Access Compliance Report

Public Rights-of-Way

(Curb Ramps)

Intersection ID: N/A	Main Street: GANNON_DR	Cross Street: COLLINS_FORD_RD	Location: NE
ADA ID: 4CA98DD5D8B8	Ramp Type: Perp	Initial Pass/Fail: Fail	Overall Compliance: No
		Severity Score: 1.25

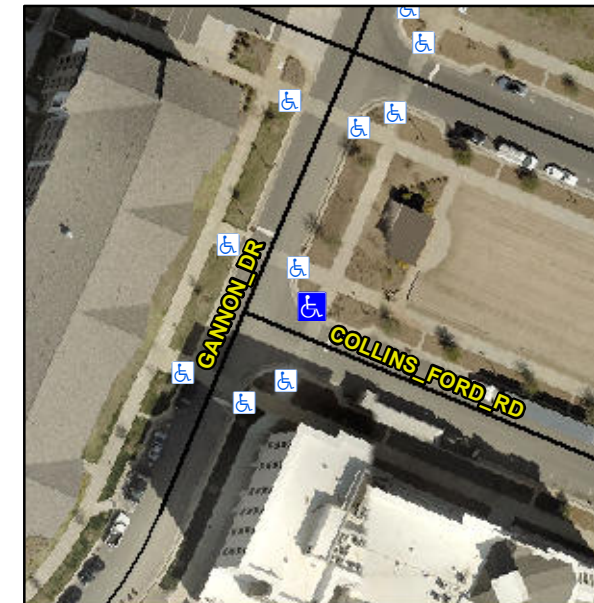
Not Found, R304.5.3

Compliance	Description	Data	Compliance	Description	Data
N/A	Ramp Length (in)	178.0	Yes	Ramp Slope (%)	5.6
Yes	Ramp Width (in)	93.0	No	Ramp XSlope (%)	2.6
N/A	Flare Type LT	N/A	N/A	Flare Type RT	N/A
N/A	Flare Slope LT (%)	N/A	N/A	Flare Slope RT (%)	N/A
N/A	Flare Traversable LT?	N/A	N/A	Flare Traversable RT?	N/A
N/A	Landing Length (in)	N/A	N/A	DWS Provided?	N/A
N/A	Landing Width (in)	N/A	N/A	DWS Contrast?	N/A
N/A	Landing Slope (%)	N/A	N/A	DWS Length (in)	N/A
N/A	Landing X Slope (%)	N/A	N/A	DWS Full Width?	N/A
N/A	Landing Curb? (Y/N)	N/A	N/A	DWS Offset (in)	N/A
N/A	Shared Landing?	N/A			
N/A	Gutter Ponding?	N/A	N/A	Gutter Slope (%)	N/A
N/A	Gutter Lip Ht (in)	N/A	N/A	Gutter X Slope (%)	N/A
N/A	Painted X Walk1?	Yes	N/A	Painted X Walk2?	N/A
	X Walk 1 Direction	To SW		X Walk 2 Direction	N/A
N/A	X Walk 1 Width (in)	97.5	N/A	X Walk 2 Width (in)	N/A
	X Walk 1 Slope (%)	3.2		X Walk 2 Slope (%)	N/A
	X Walk 1 X Slope (%)	1.3		X Walk 2 X Slope (%)	N/A

Remove & Replace Entire Ramp.
